DEPARTMENT OF TRANSPORTATION

July 7, 2022

> RE: Preliminary Plan No. 120220010 Miles Coppola Preliminary Plan & Traffic Impact Study Letter

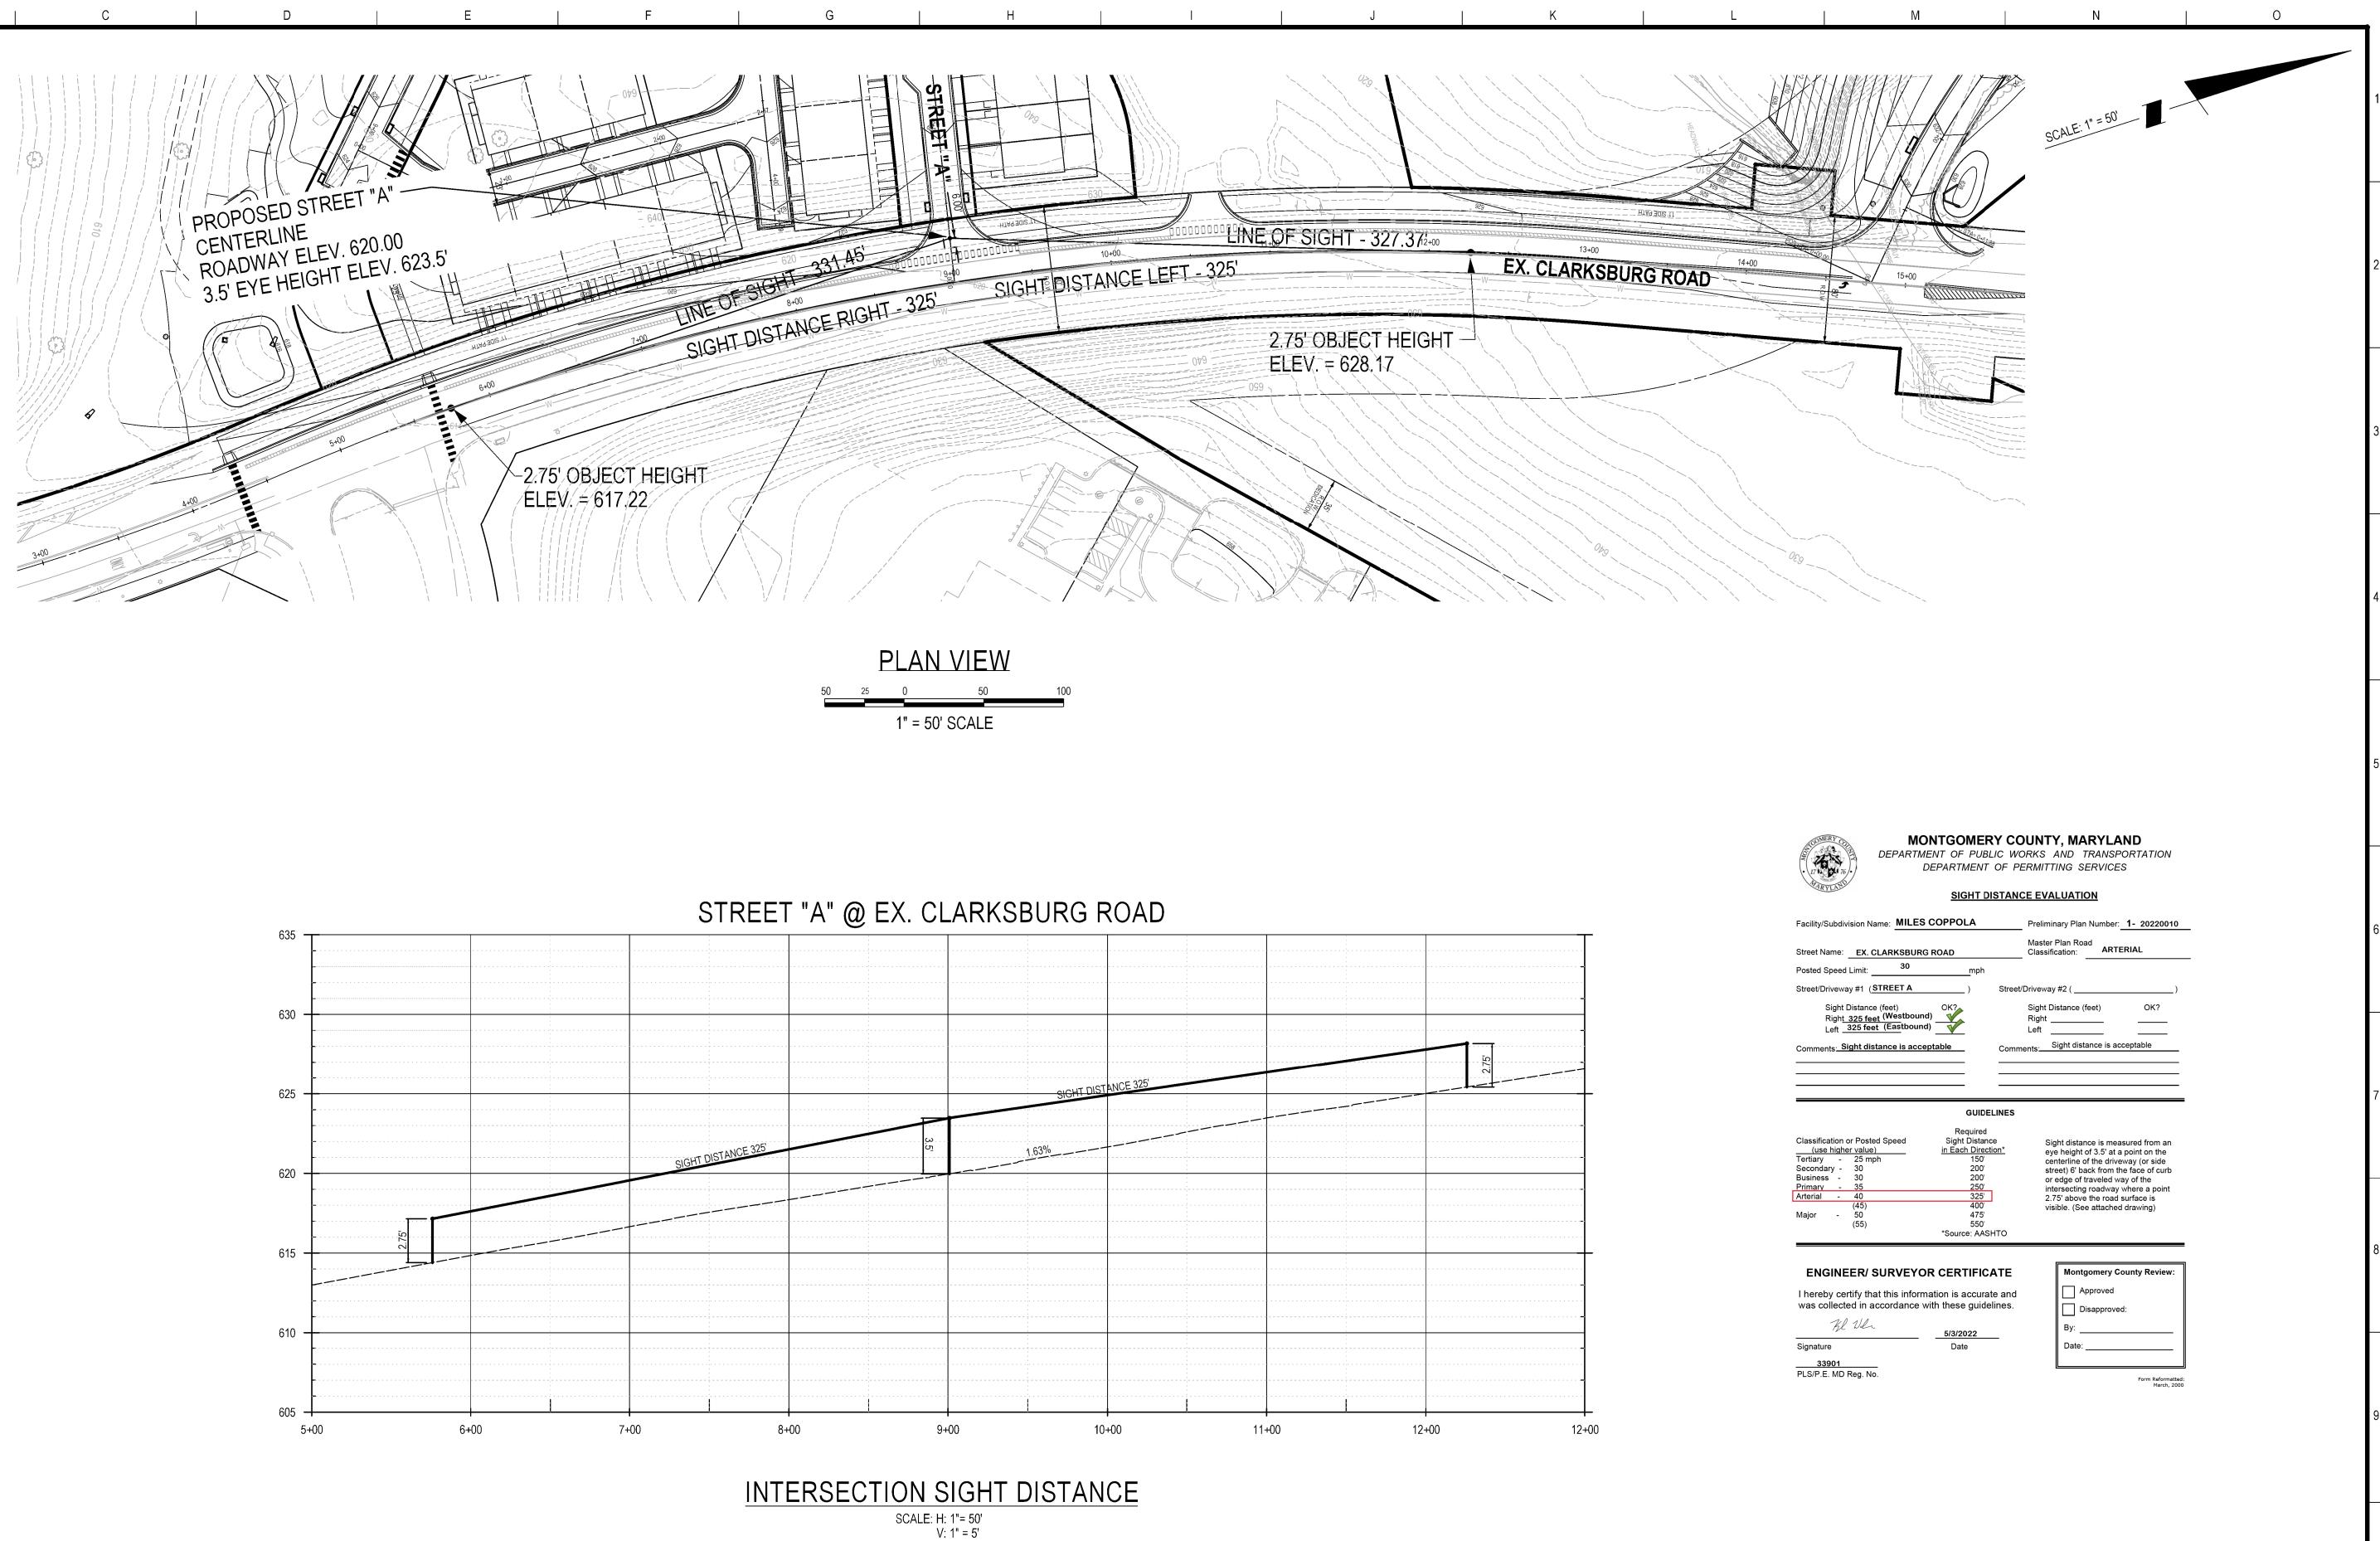
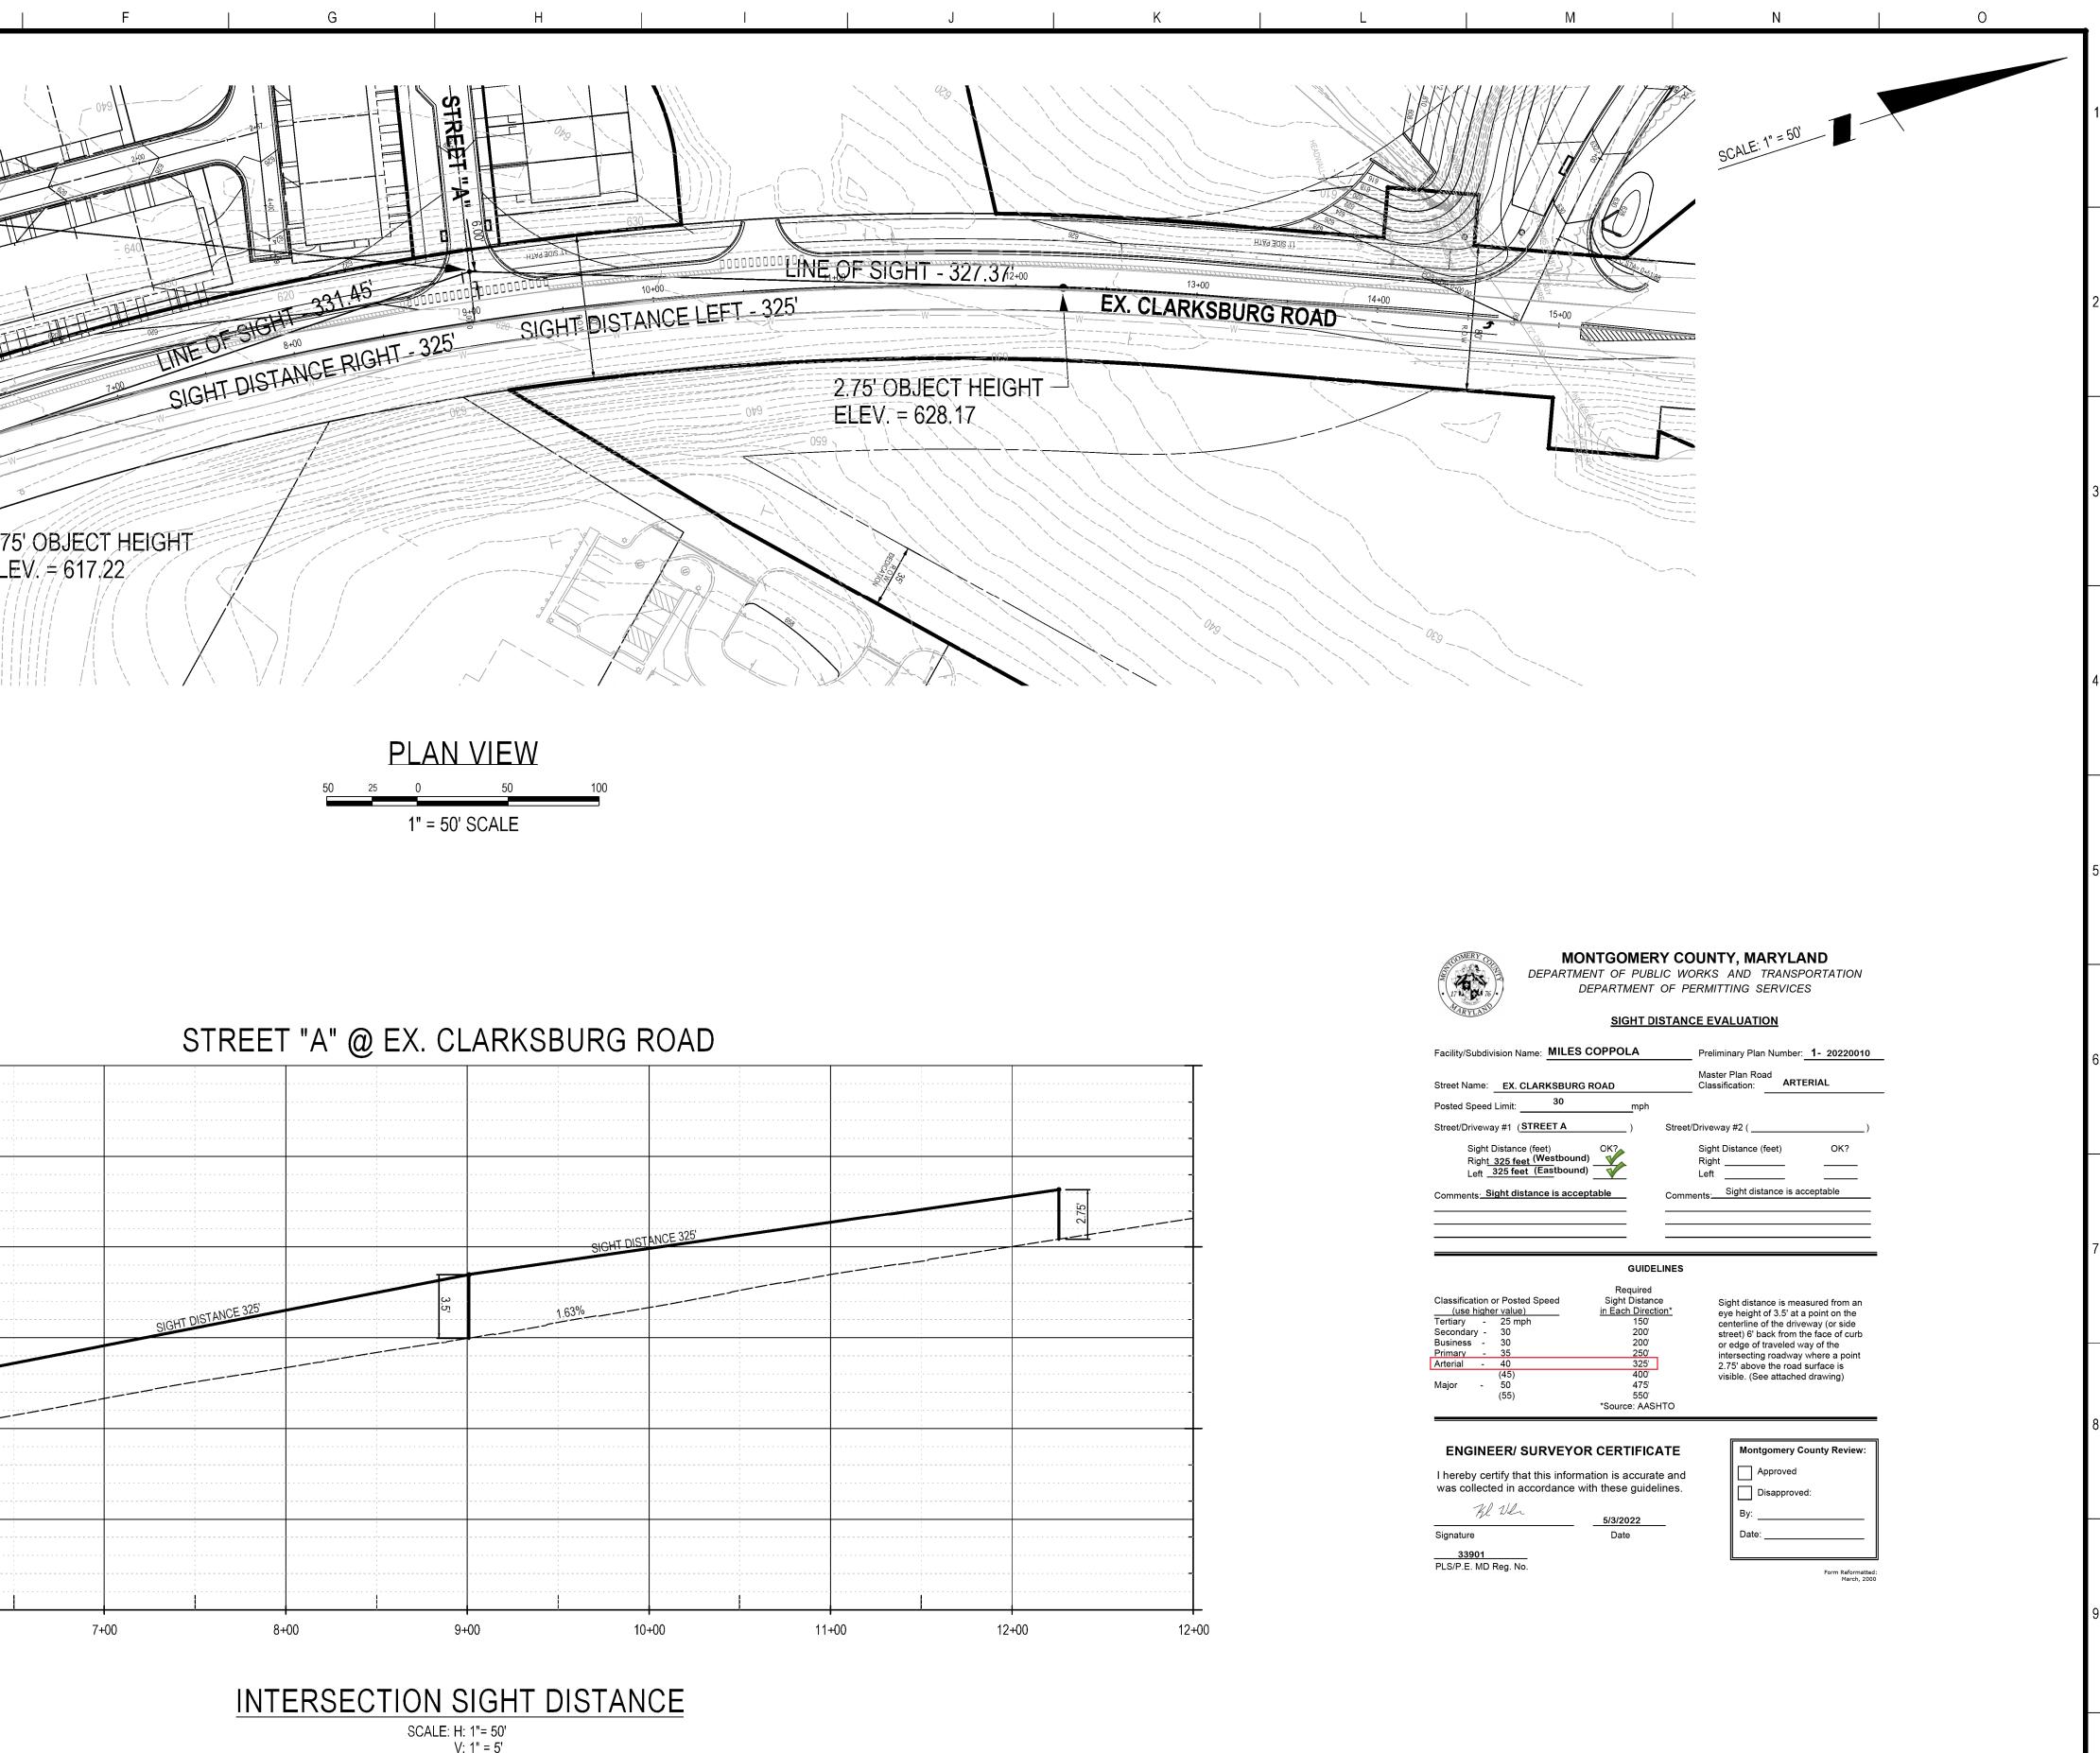
Facility/Subdivision Name: MILES COPPOLA	Preliminary Plan Number: 1- 20220010
Street Name: EX. CLARKSBURG ROAD	Master Plan Road Classification: ARTERIAL
Posted Speed Limit:mph	
Street/Driveway #1 (STREET A)	Street/Driveway #2 ()
Sight Distance (feet) OK? Right <u>325 feet</u> (Westbound) Left <u>325 feet (Eas</u> tbound)	Sight Distance (feet)OK?RightLeft
Comments: Sight distance is acceptable	Comments:Sight distance is acceptable

Montgomery County Review:
Approved
Disapproved:
By: Brenda M. Pardo
Date: 6/7/22

PRIMARY ACCESS ROAD @ EX. CLARKSBURG ROAD

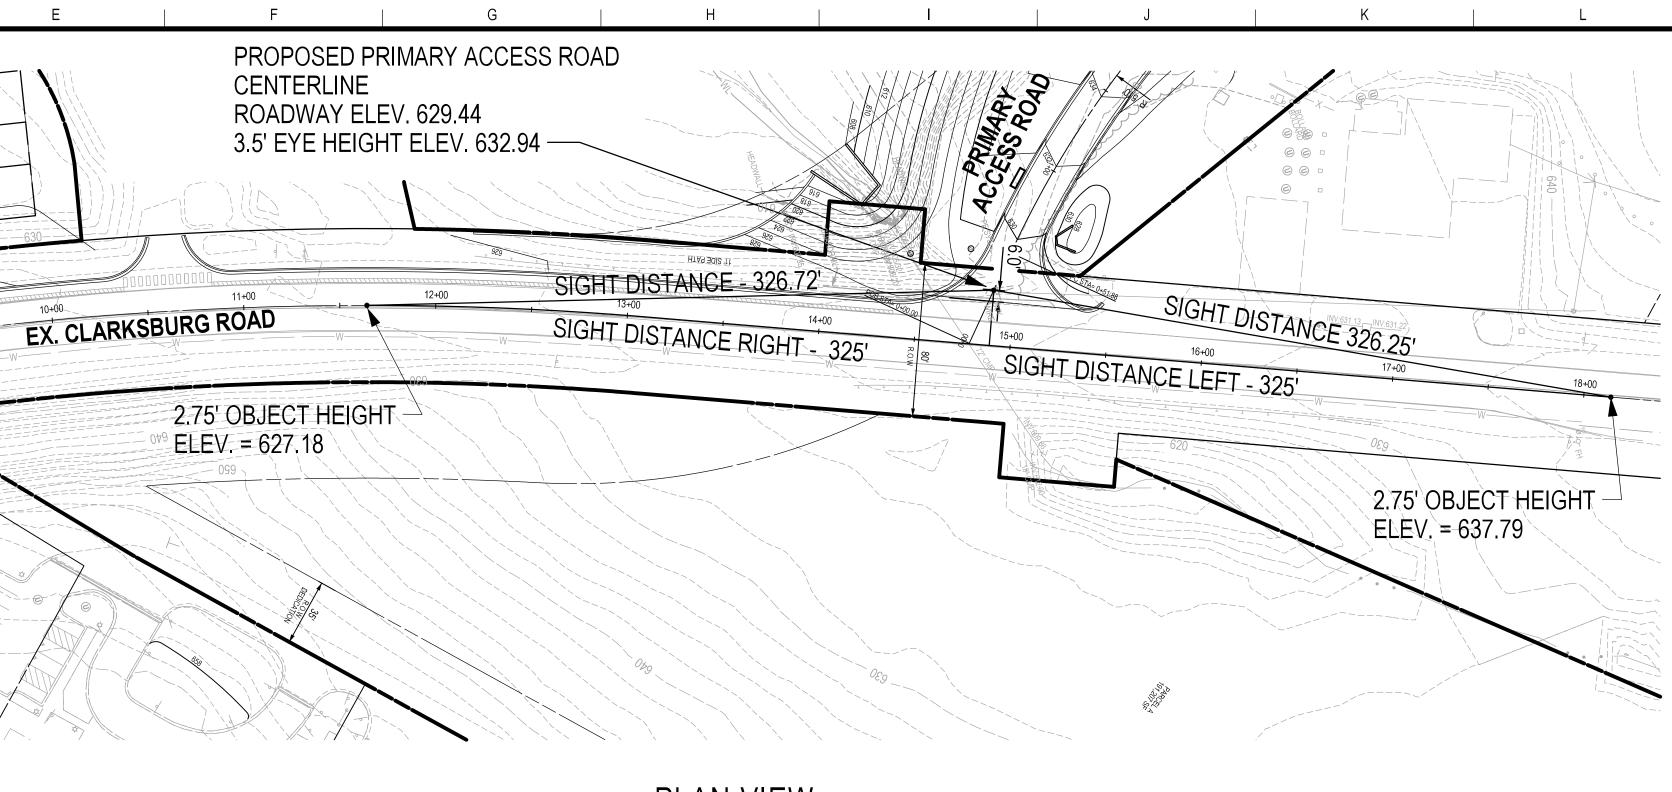
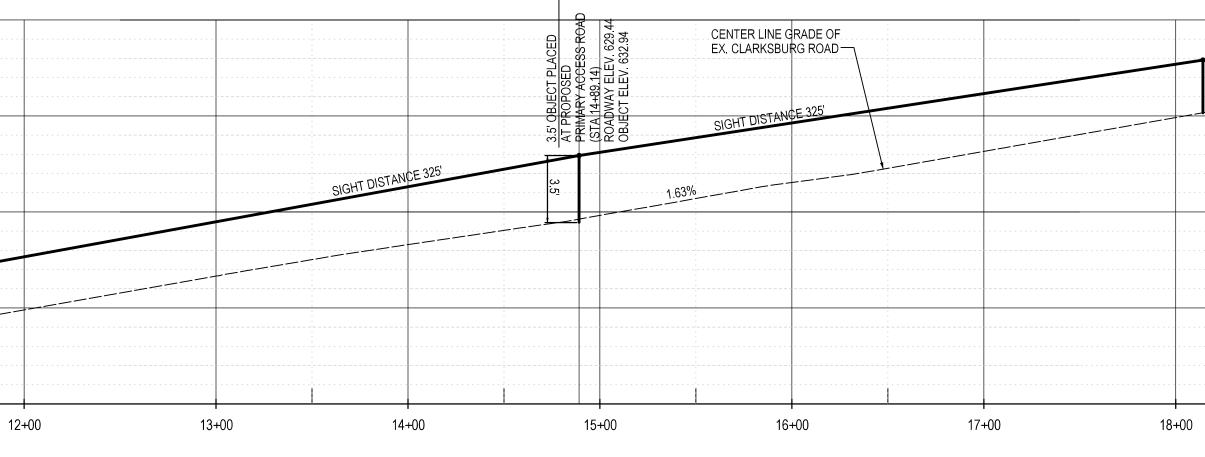
Facility/Subdivision Name: MILES COPPOLA	Preliminary Plan Number: 1- 20220010
Street Name: CLARKSBURG ROAD	Master Plan Road Classification: ARTERIAL
Posted Speed Limit: 30mph	
Street/Driveway #1 (PRIMARY ACCESS ROAD	Street/Driveway #2 ()
Sight Distance (feet) OK? Right <u>325 feet</u> (Westbound) Left <u>325 feet (Eas</u> tbound)	Sight Distance (feet)OK?RightLeft
Comments: Sight distance is acceptable	Comments: Sight distance is acceptable

Montgomery County Review:
Approved
Disapproved:
By: Brenda M. Pardo
Date: <u>6/7/22</u>
